MOUNT JOY TOWNSHIP

LOT ADD - ON PLAN **FOR**

Re: Jacob Huyard Lot-Line Change Plan

Lot Add-On Plan

SHEET 2 OF 2 - LOT ADD-ON PLAN **

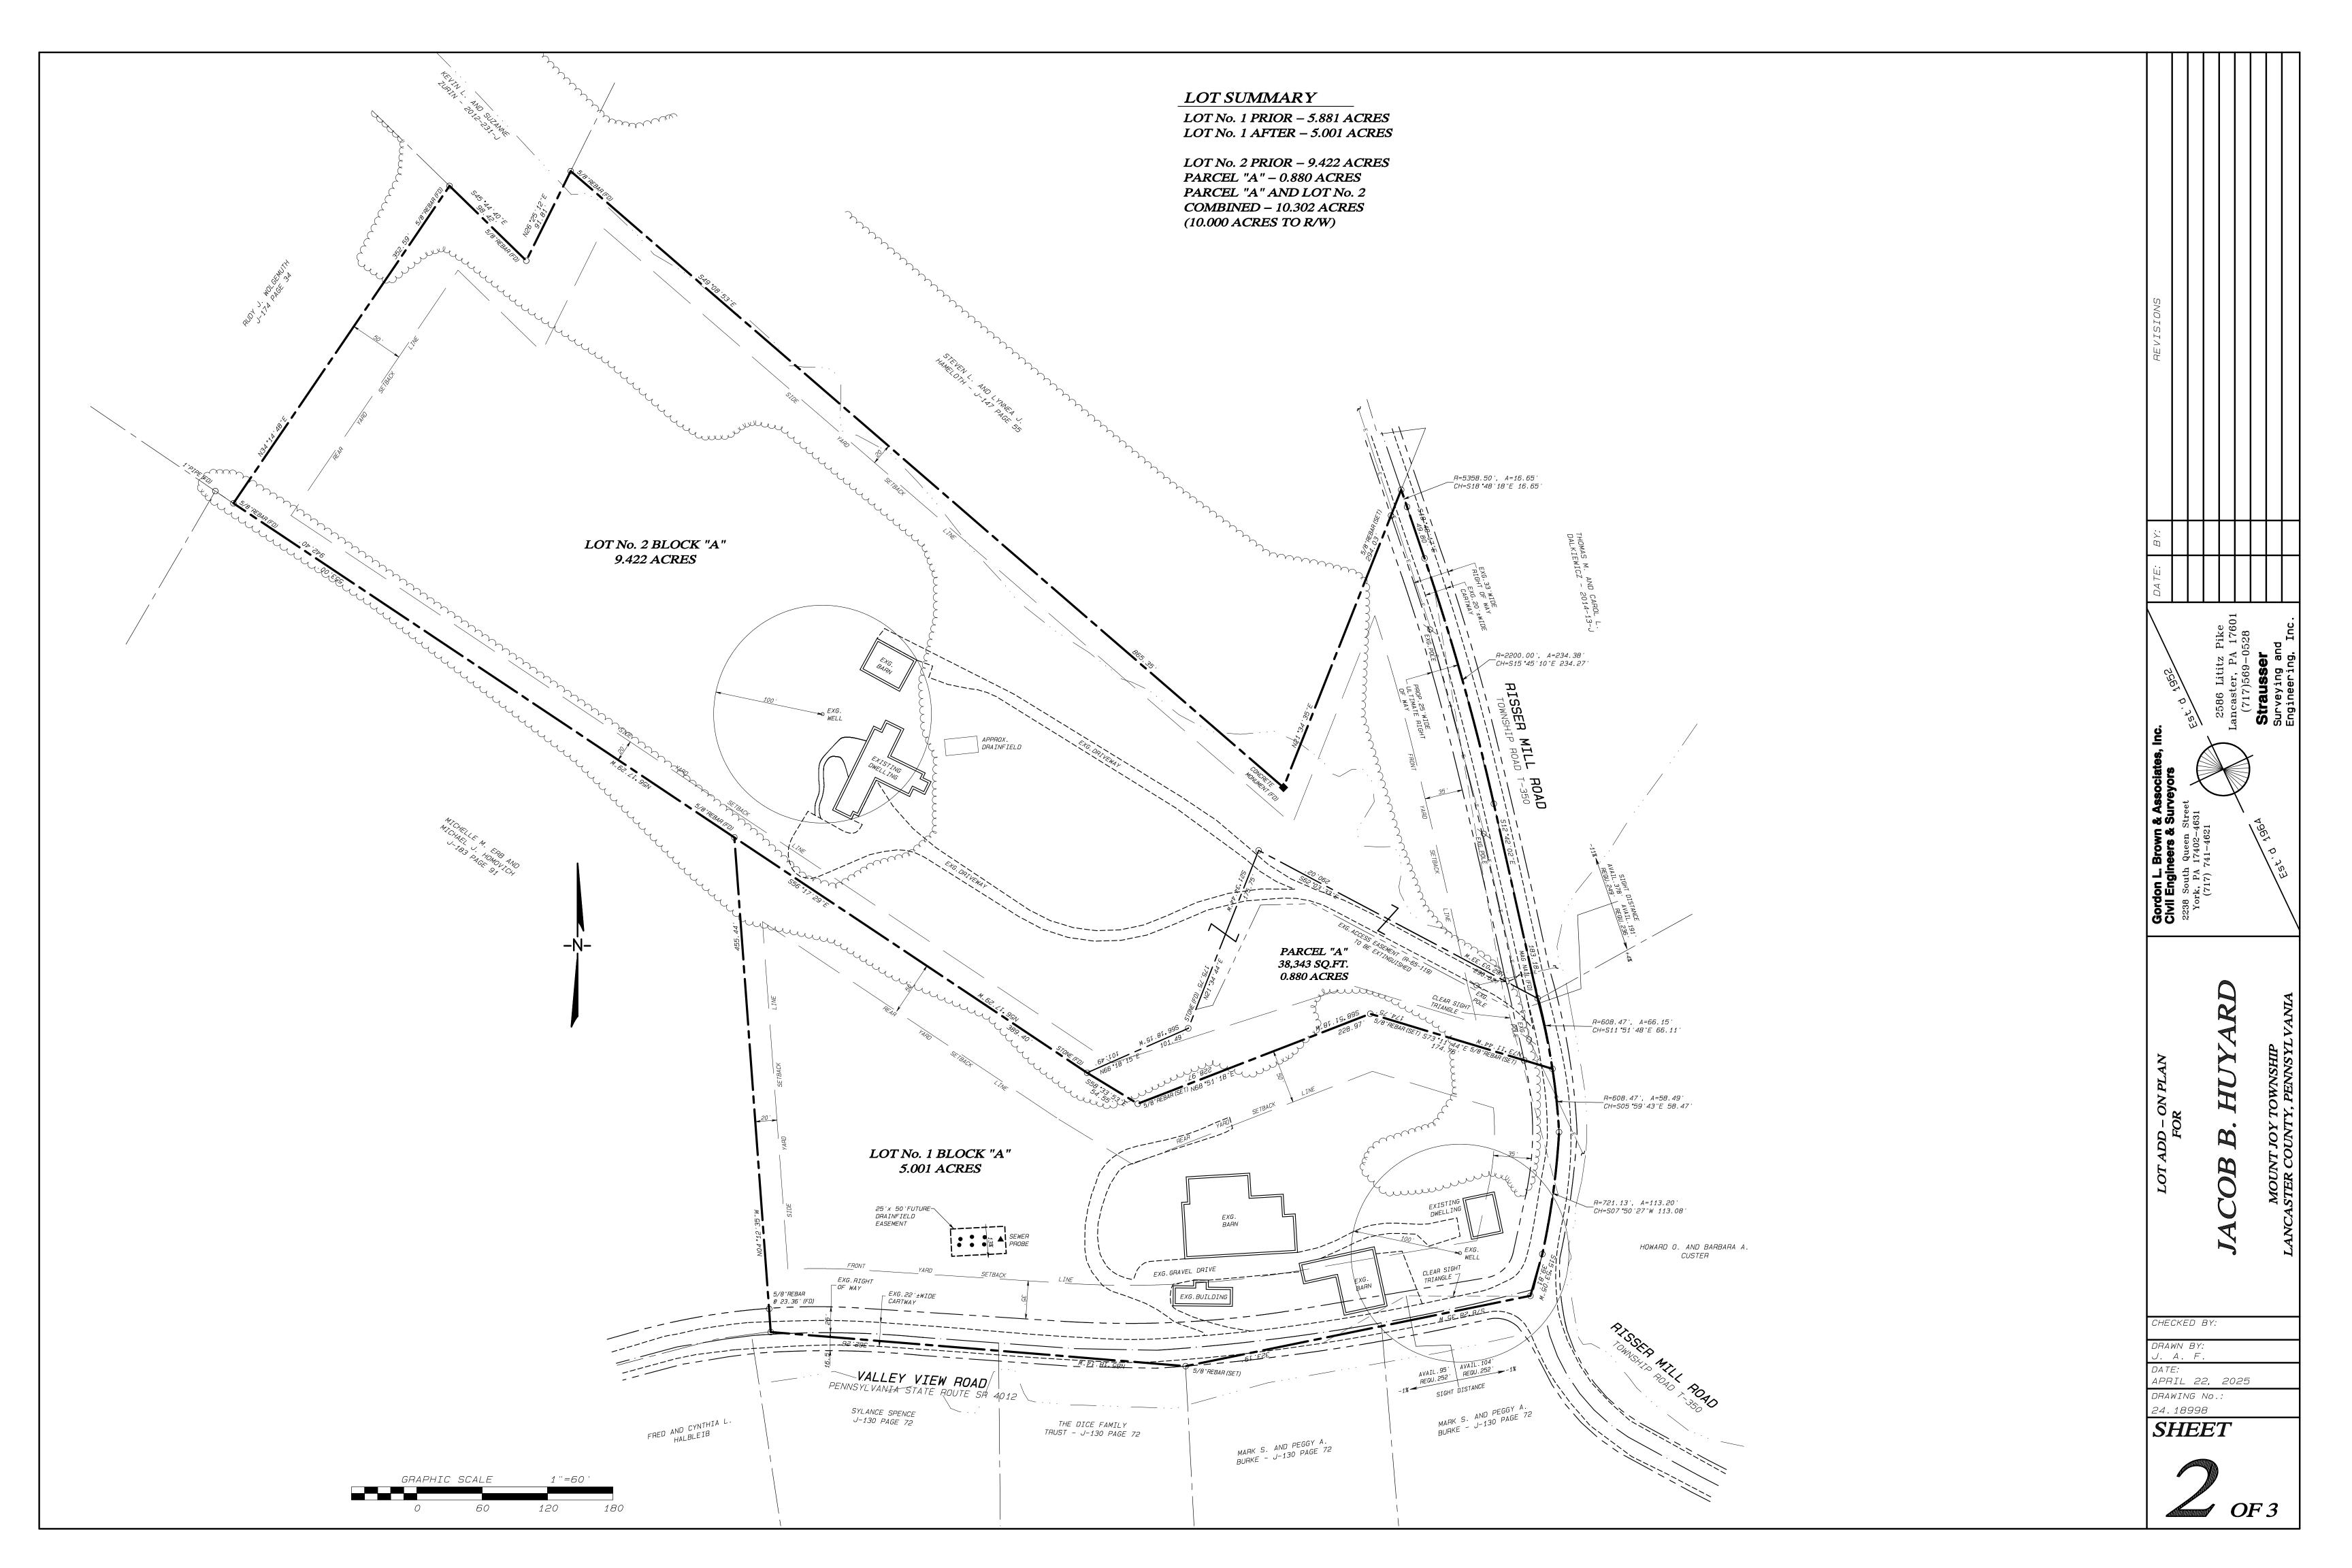
- 4. The minimum front yard setback requirement for "all other buildings" shall be provided on the Cover Sheet (135-85.F(1)).
- 5. The northerly "required" stopping sight distance shall be corrected for the Lot No. 2 driveway (135-299.E(2) & 119-31.D(12)).

6. Plan Note #8 shall be corrected (i.e. Parcel A is being joined to Lot No. 2) (119-31.A(3)).

- 7. The total number of sheets for Sheet 2 shall be corrected (119-31.A(3)).
- 8. It is recommended that a linetype and symbol legend be added to the plans (119-31.A(4)).

- 9. The plans shall be signed by a registered engineer, surveyor or landscape architect (119-31.A(5)).
- 10. The sum of the individual areas of Lot No. 2 Block "A", Parcel "A", and Lot No. 1 Block "A" shown on Sheet 2 and in the Lot Summary table (15.303 acres) is inconsistent with the Number of Acres shown in the Site Data table (15.290 acres) (119-31.B(6)).

- 16. The Lot Summary table on Sheet 2 should distinguish between the net and gross lot area for Lot No. 1 (119-31.D(9)).
- 17. The existing and proposed lot widths and lot depths for each lot shall be provided (119-31.D(9)).

- 19. A wetlands study shall be provided (119-35.E(3)(c)).
- 20. Bearings and distances shall be provided for the new lot line and curves that will result from the dedication of the proposed right-of-way (119-35.D(2)).

- 23. Plan Note #11 indicates that "no areas are being proposed for dedication on this plan"; however, Sheet 2 indicates that street right-of-way is proposed (119-35.E(2)(d)). This should be clarified in the plans.
